**TOWN OF HERNDON, VIRGINIA
PLANNING COMMISSION PUBLIC HEARING AGENDA
MARCH 25, 2019
HERNDON COUNCIL CHAMBERS BUILDING
765 LYNN STREET
7:00 P.M.**

Subject: Proffer Condition Amendment Application, PCA#19-01, 525 Grove Street

RE: Vertical Bridge US-VA-5060 – Herndon Substation
525 Grove Street
Proffer Condition Amendment #19-01 - **Revised**

PROFFERS**“Generalized Development Plan, US-VA-5060 Herndon Substation”****PCA #19-01****Amendment to ZMA-02-102****February 26, 2019**

PHILIP BURTNER, P.E.
VA PROFESSIONAL ENGINEER LIC. #0022023

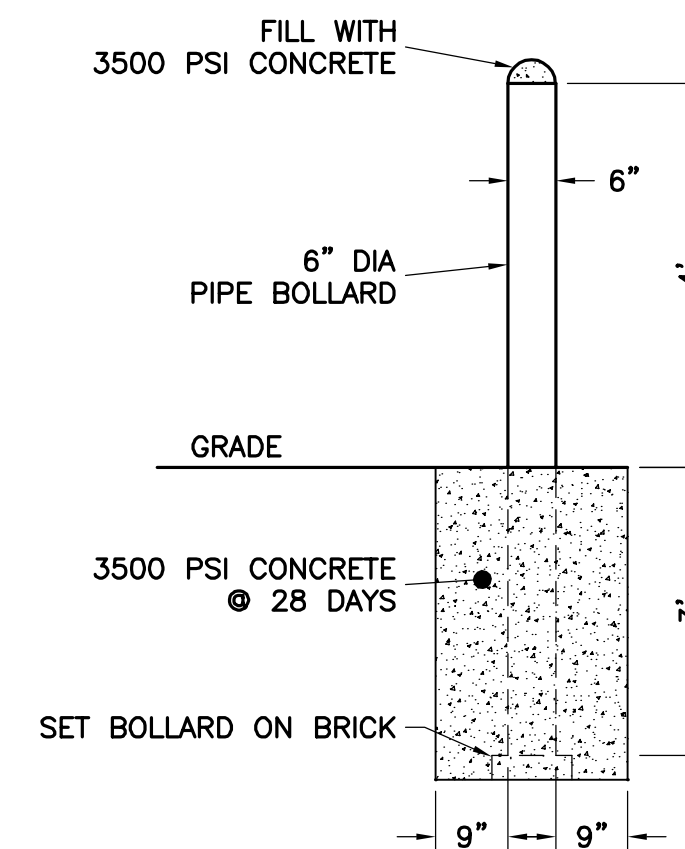
9. Fence elevation on sheet C-1 indicates two gates. This does not match with the proposed plan on sheets Z-1 and Z-2. It is recommended that only one gate be installed and with direct connection on-site to the internal access road.

The fence detail has been revised to shown just one gate. However, applicant objects to any limitation on the ability for an additional gate(s) to be added in the future, if it might allow better access in and around the compound by carriers who may collocate on the proposed tower. The gates are for pedestrian access, not vehicular access, and vehicular access has been adequately limited the gravel driveway along the north side of the property.

D-1
SHEET 5 OF 7

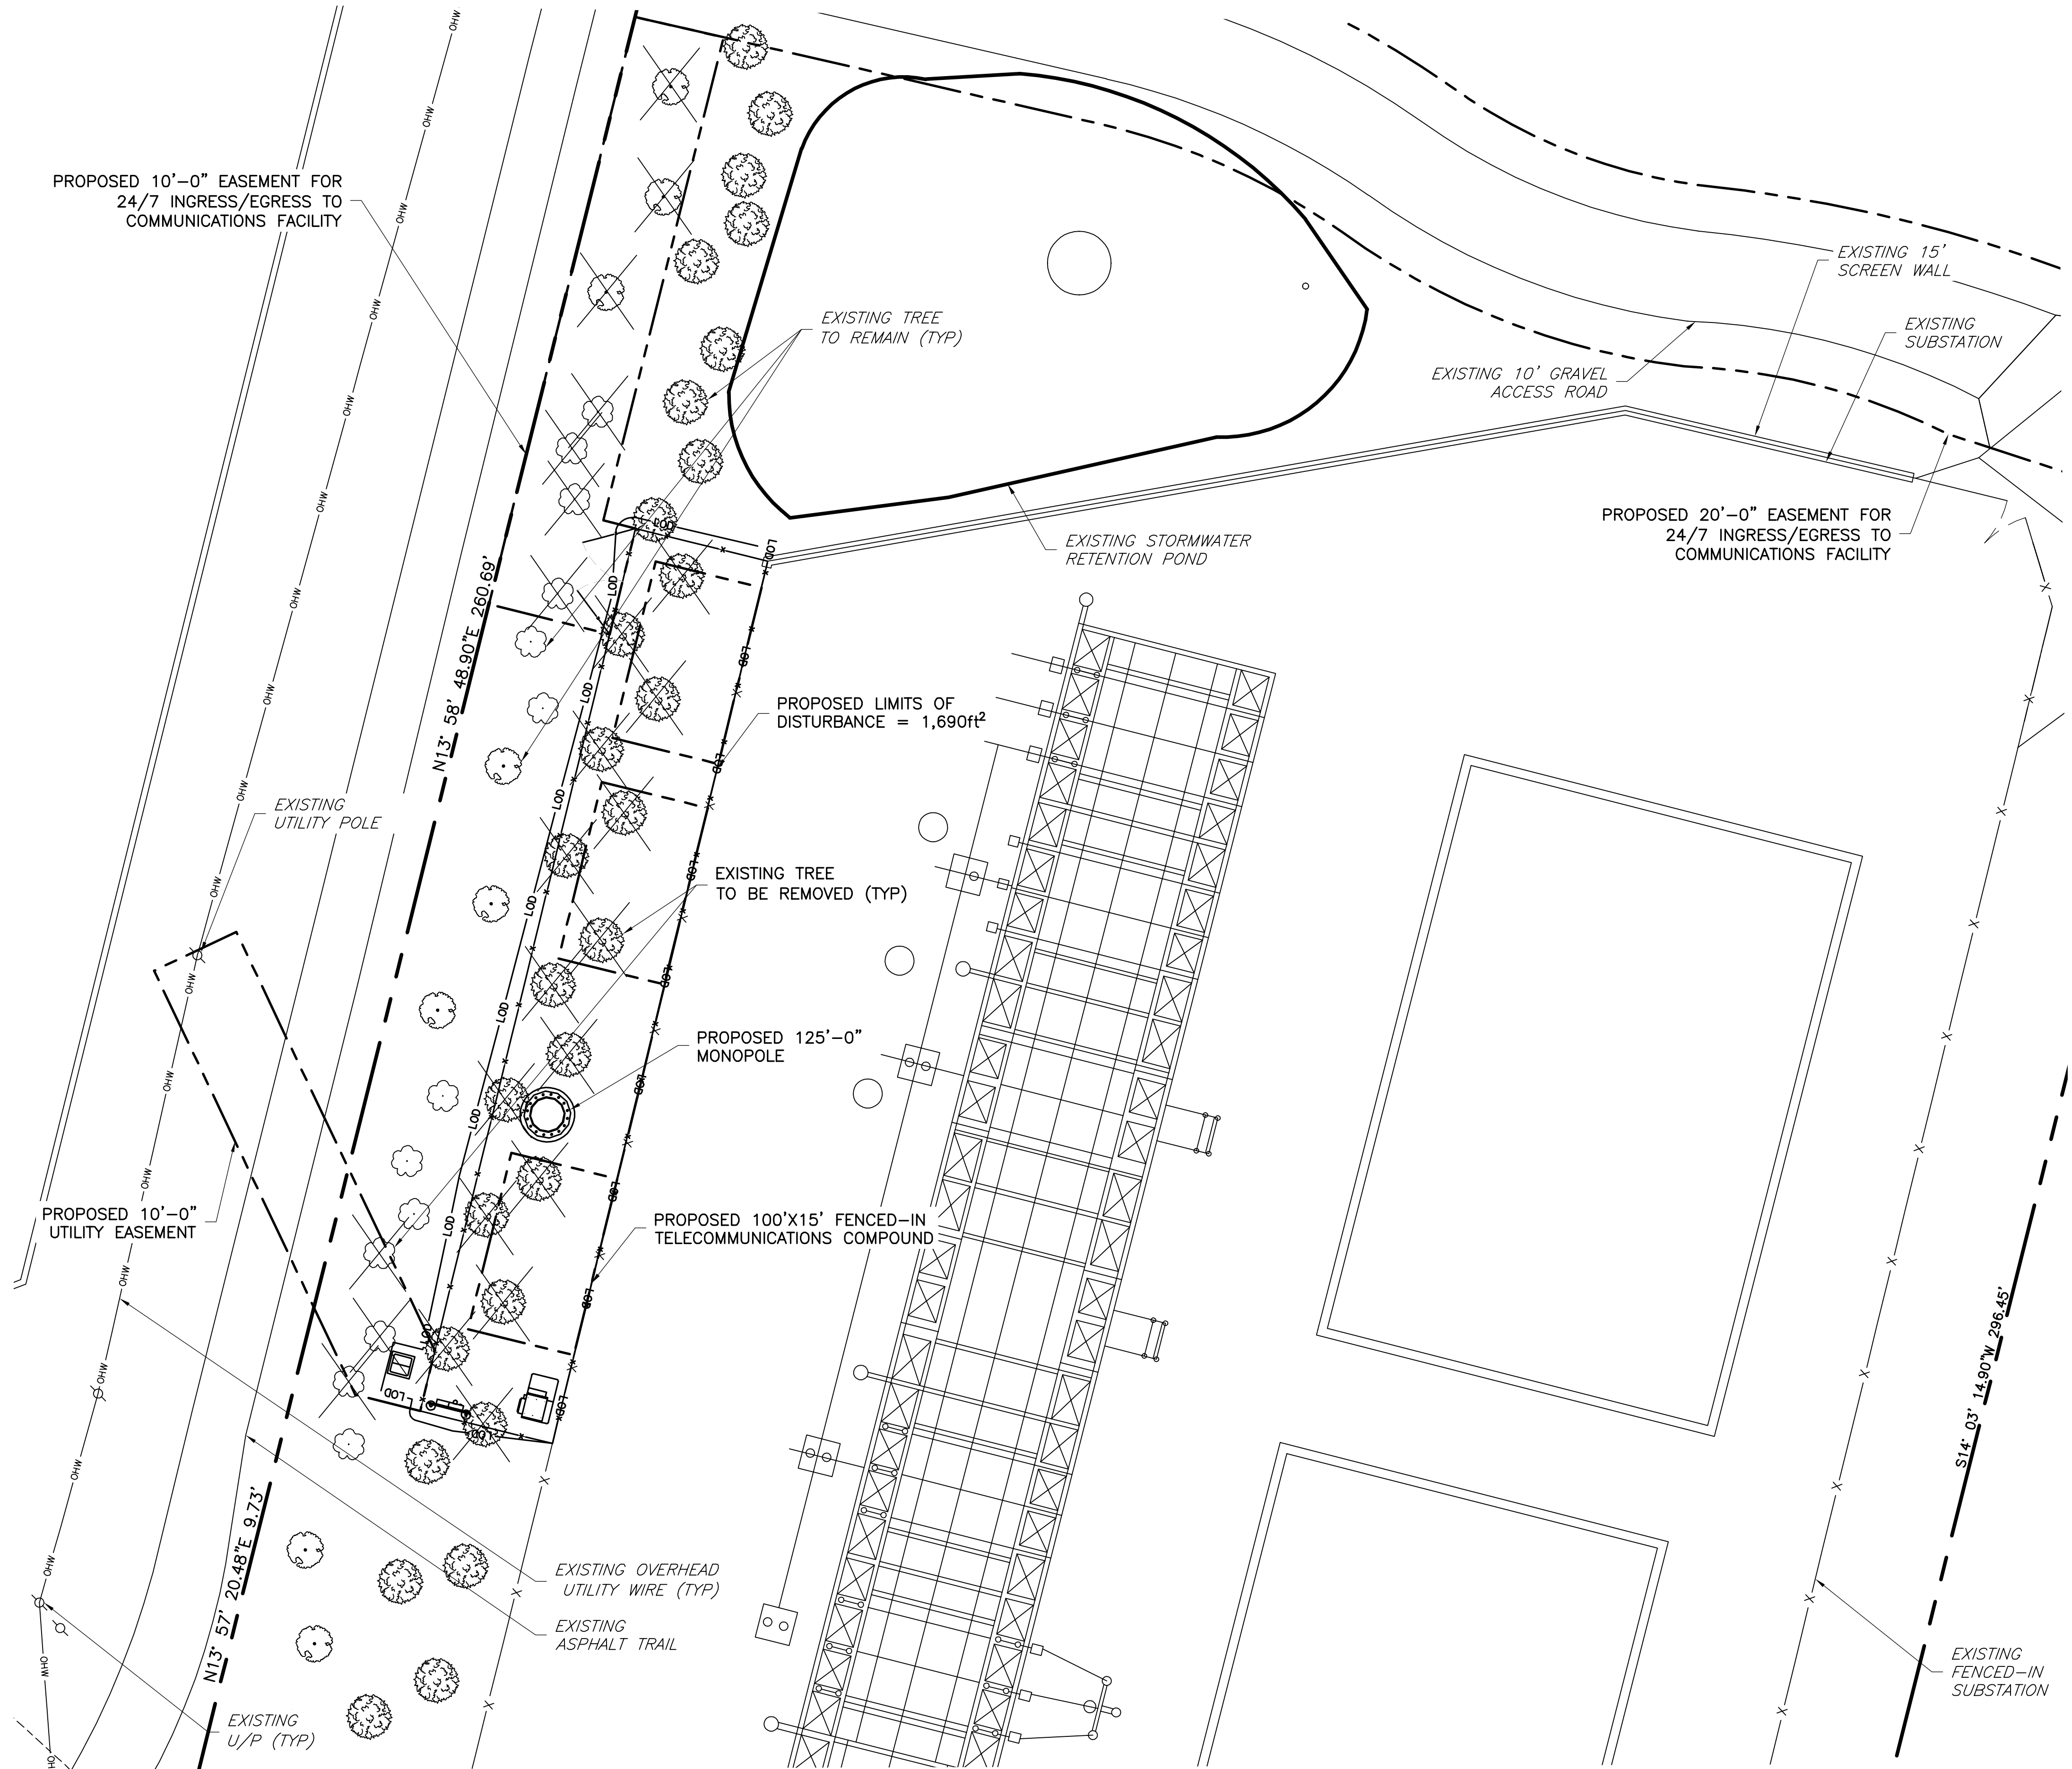
1. The Town's fence regulations, found in the Zoning Ordinance, do not permit chain link fences for this type of use. Chain link fences can only be placed around recreational facilities, construction sites, construction staging areas, and schools. Barbed wire fences are not permitted in any zoning district in the Town. Therefore, the proposed chain link fence section shown on sheet D-1 must be revised to show a different screening.
